Technical Basis for CASS Aging Management “Combined effects of TE & IE”

NRC Staff Review of PWROG-15032-NP, Statistical Assessment of PWR RV Internals CASS Materials

Staff Assessment of PWROG-14048-P

Acceptance criteria

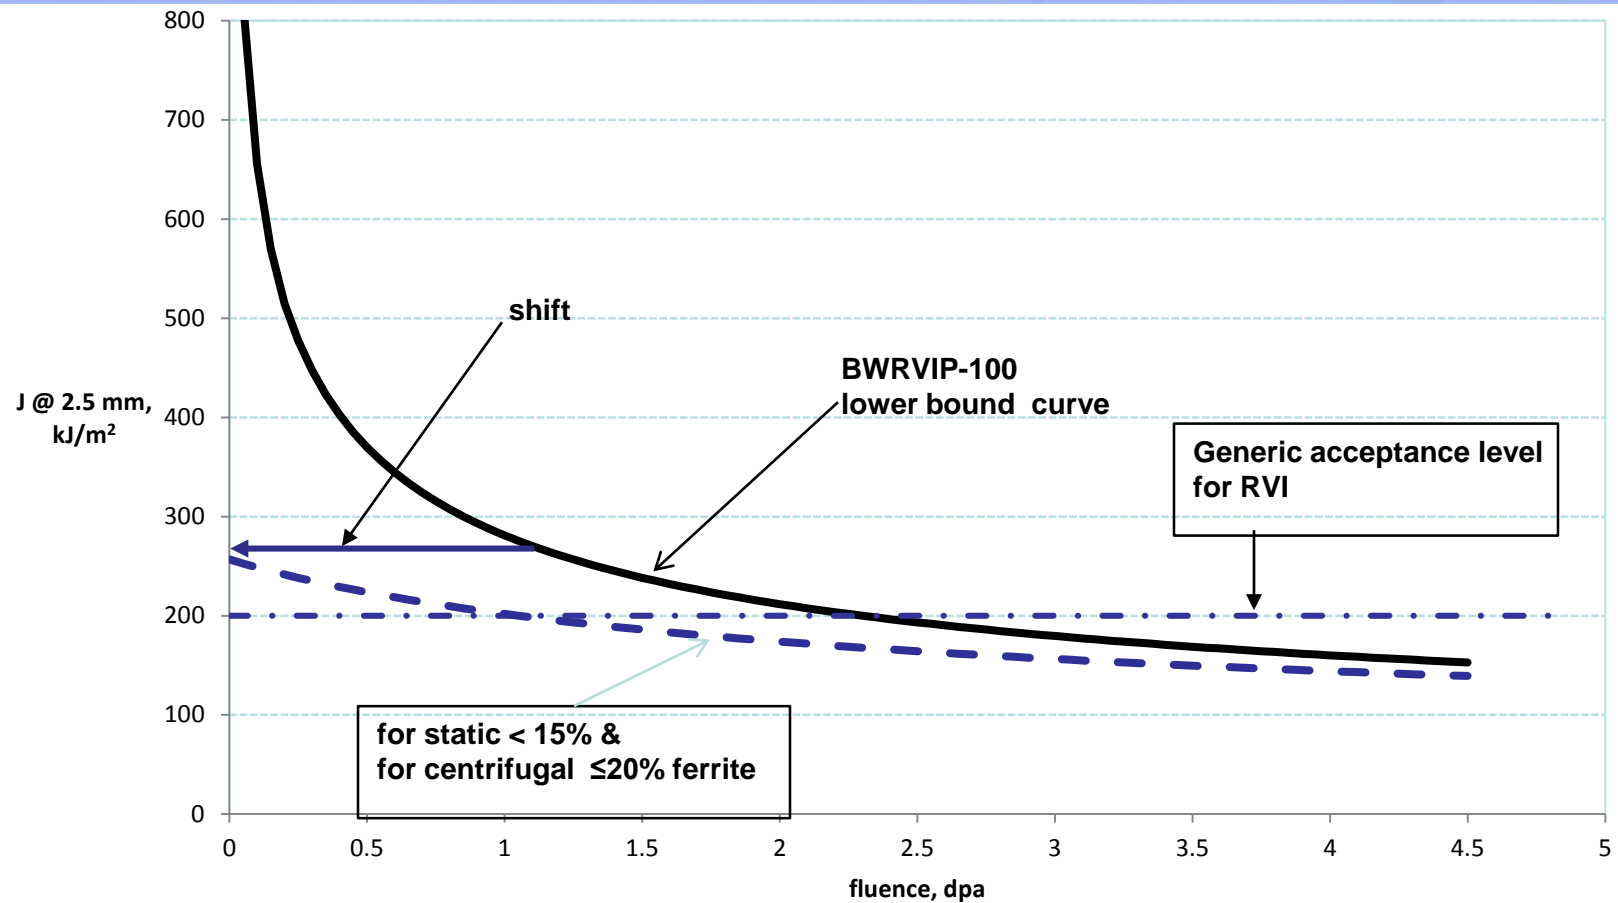
- MRP based fluence and ferrite screening limits to correlate with $J_{2.5} > 255 \text{ kJ/m}^2$, consistent with criteria established by generic piping component flaw tolerance analysis.
- For RVIs, Attachment C to BWRVIP 2015-025 cites three generic cases that suggest the crack driving forces are much lower, 4 to 83 kJ/m^2 .
- Given the lower generic driving forces, the staff recommends the toughness basis for the screening criteria be reduced from 255 to 200 kJ/m^2 .

Fracture Toughness - Variability at 15% ferrite

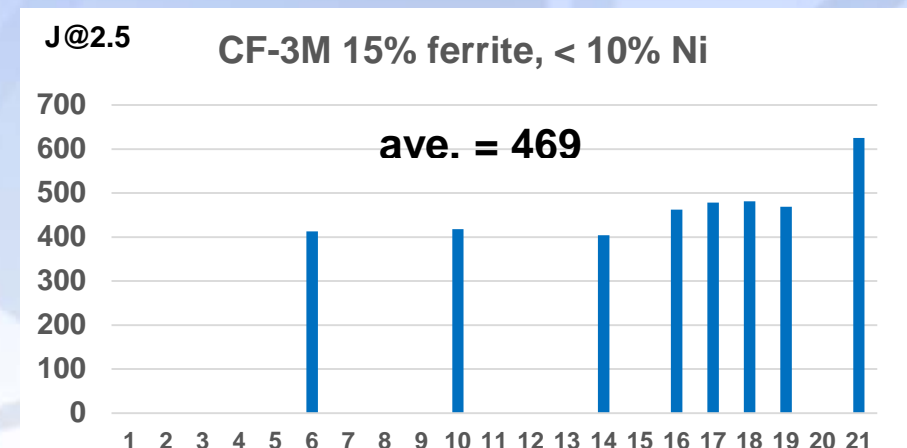
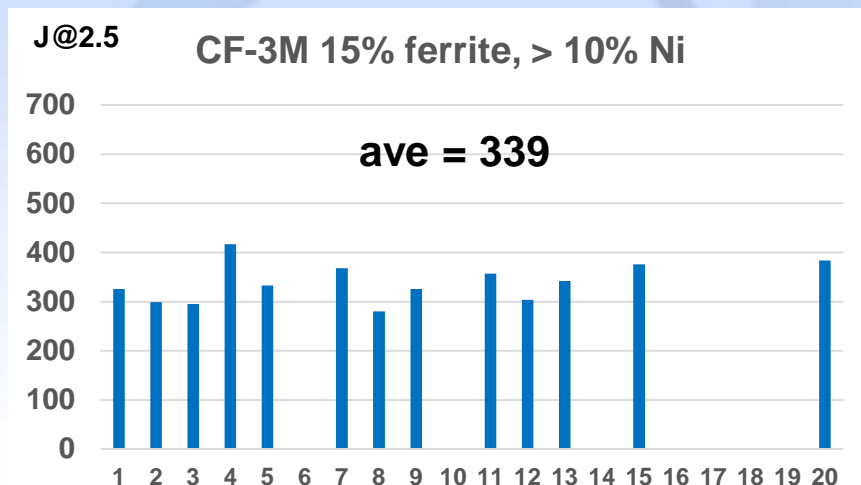
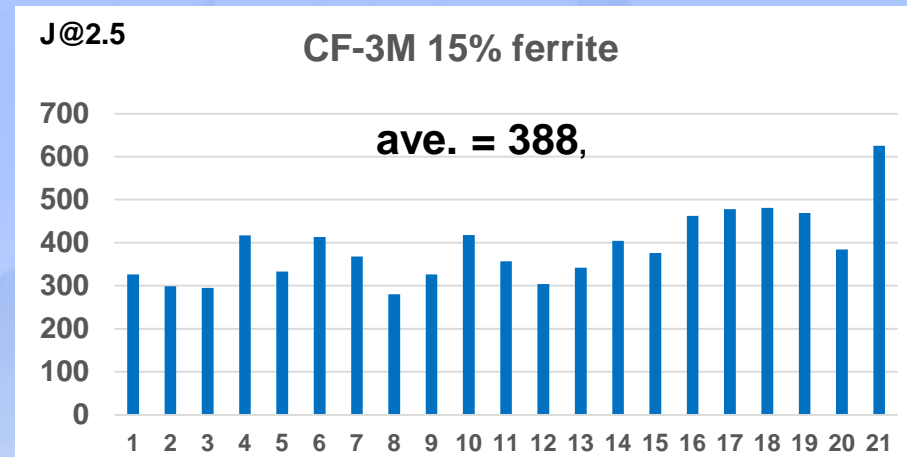
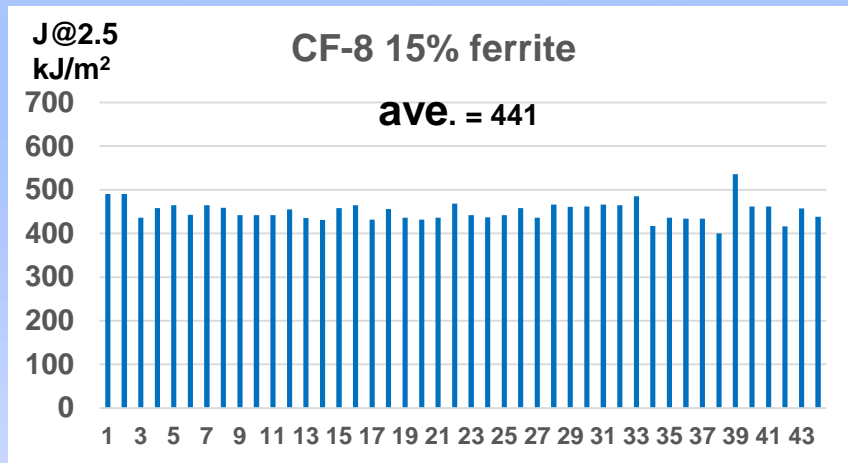
- For each heat, fracture toughness ($J_{2.5}$) estimated using NUREG/CR-4513 and NUREG/CR-7185 equations for known composition
- 95/95 lower bound toughness then determined from these $J_{2.5}$ estimates
- Manufacturer 95/95 lower bound $J_{2.5}$ determined this way are higher than if $J_{2.5}$ determined using equations for known ferrite, unknown composition. (Draft RAI 4)
- For heats of same material grade and casting method with the same estimated ferrite, toughness varies widely
